Addendum #1 for
St. Joseph University Catholic Parish
Terre Haute, IN
Parish Hall
September 15, 2026

entheos ARCHITECTS
802 Lord Street, Ste. 200
Indianapolis, IN 46202
Ph (317) 951-9590

CHANGES TO THE DRAWINGS

2 Section @ Steps
Scale: 1-1/2" = 1'-0"

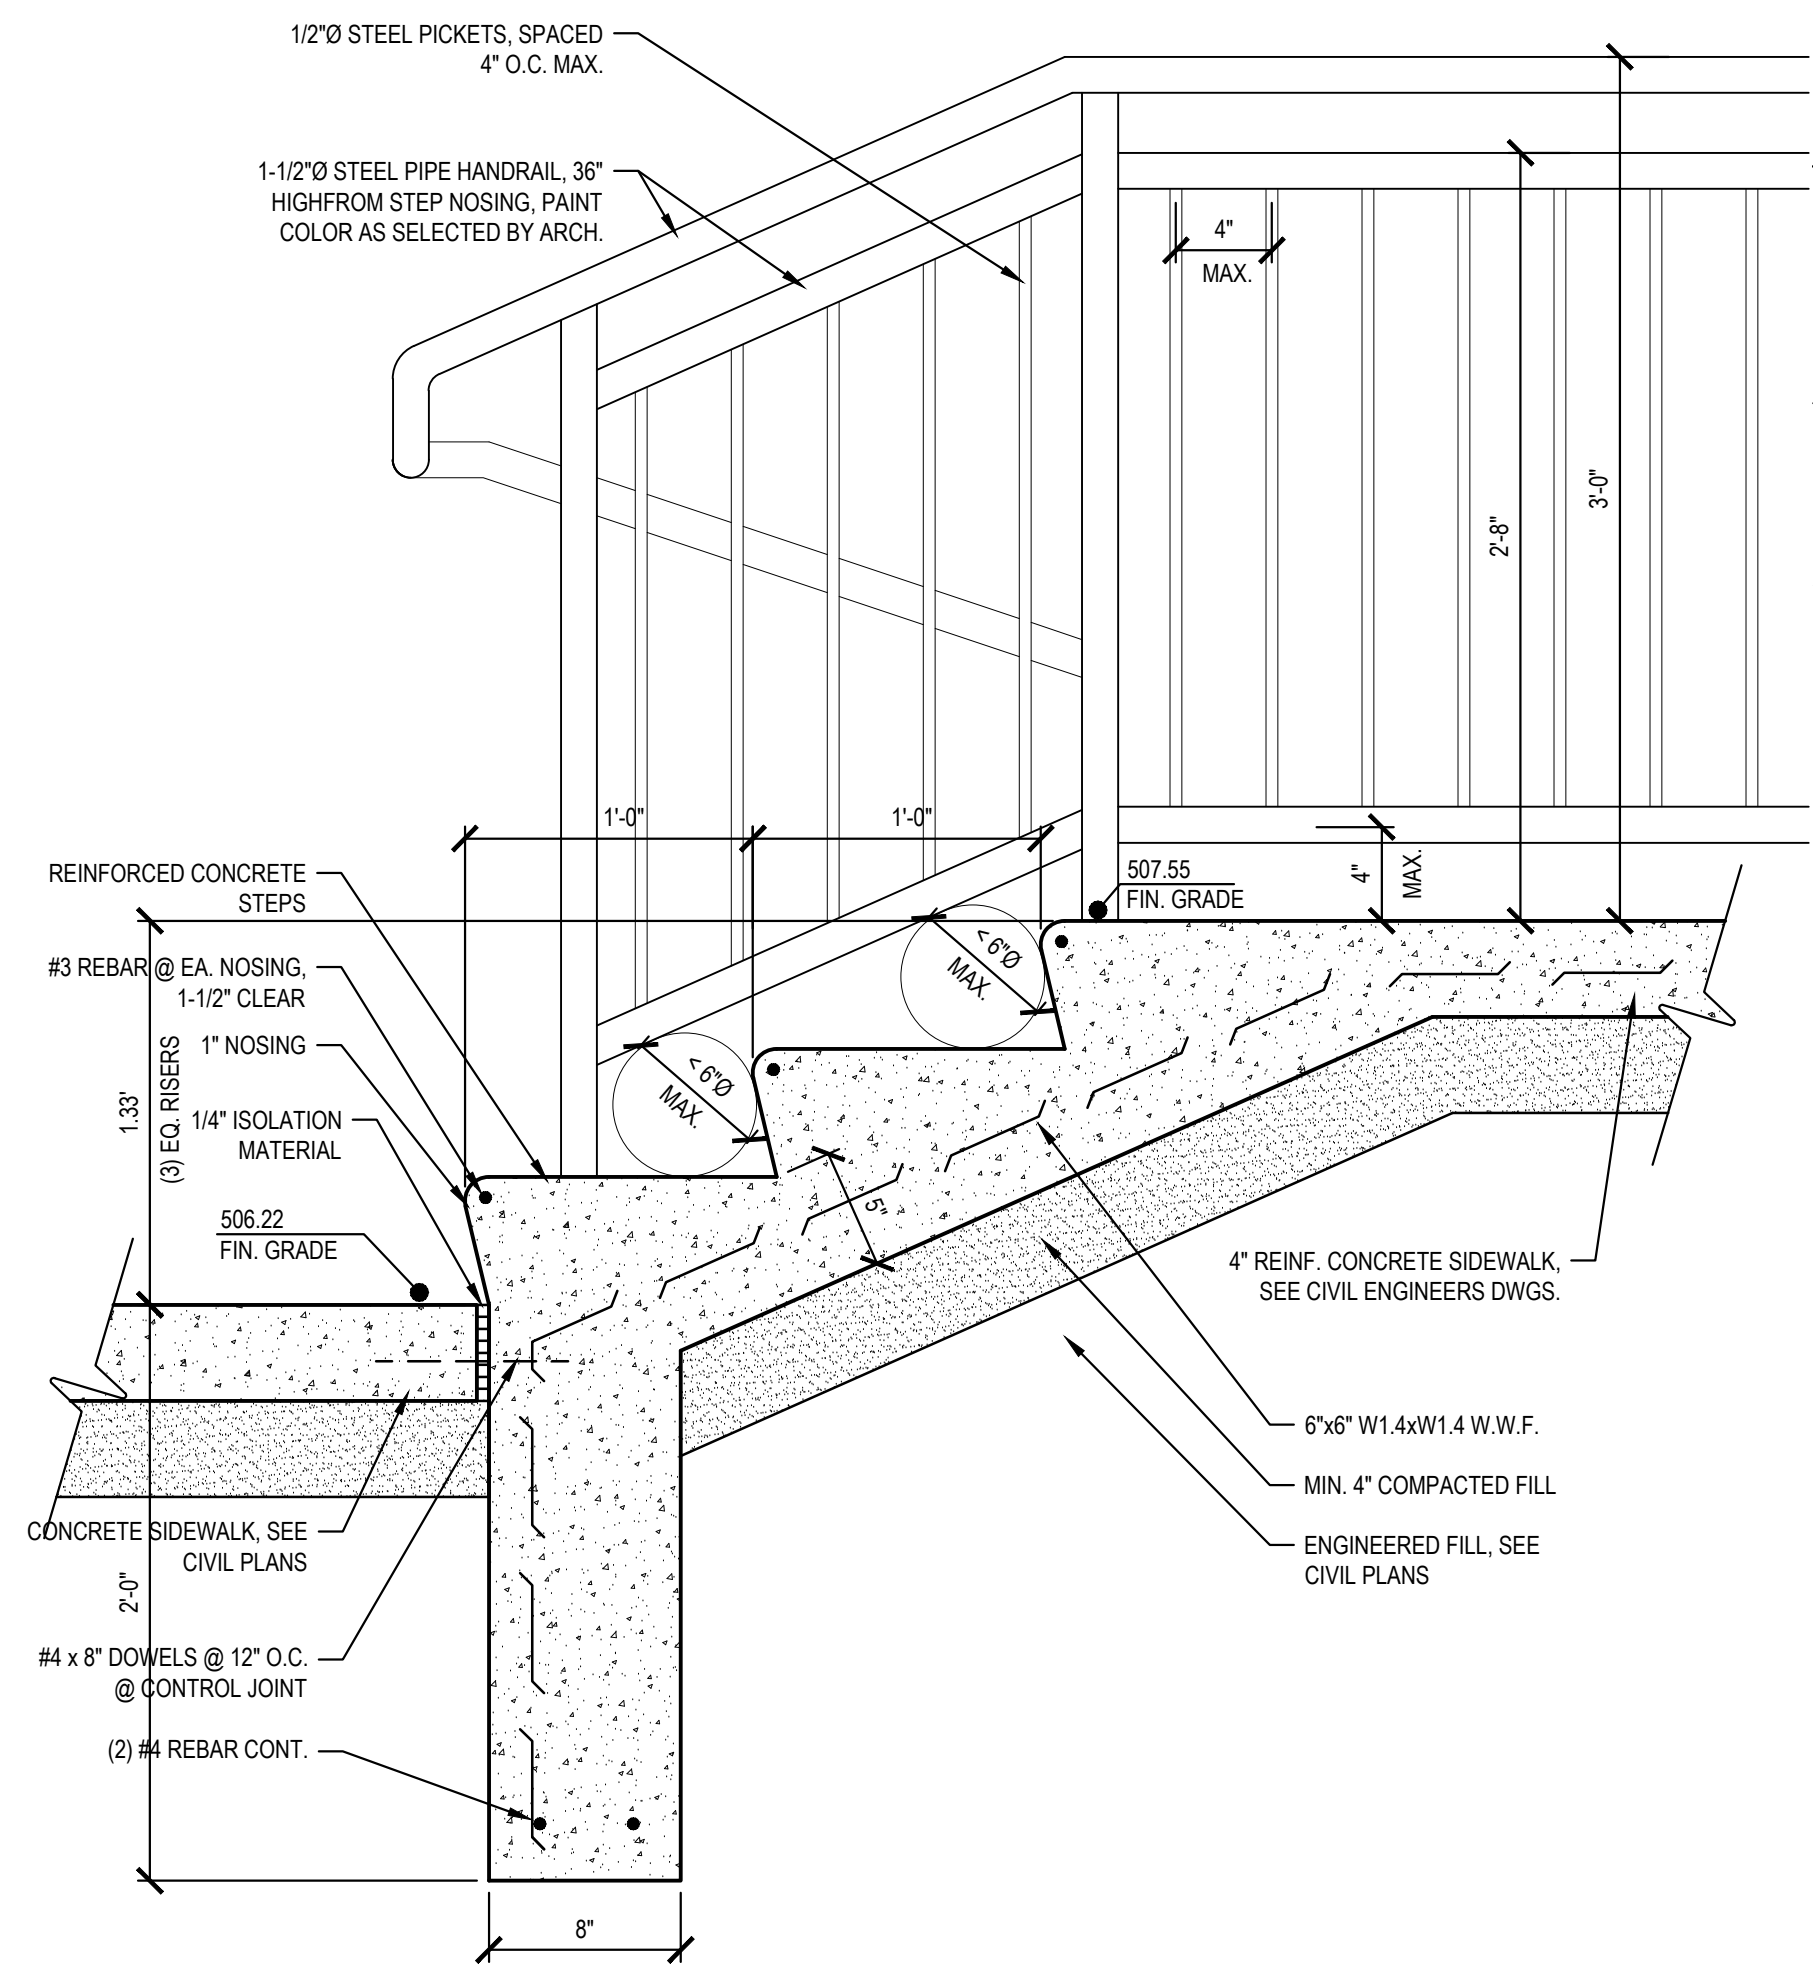
2. Revise Step and Railing Details. Replace sheet in entirety.
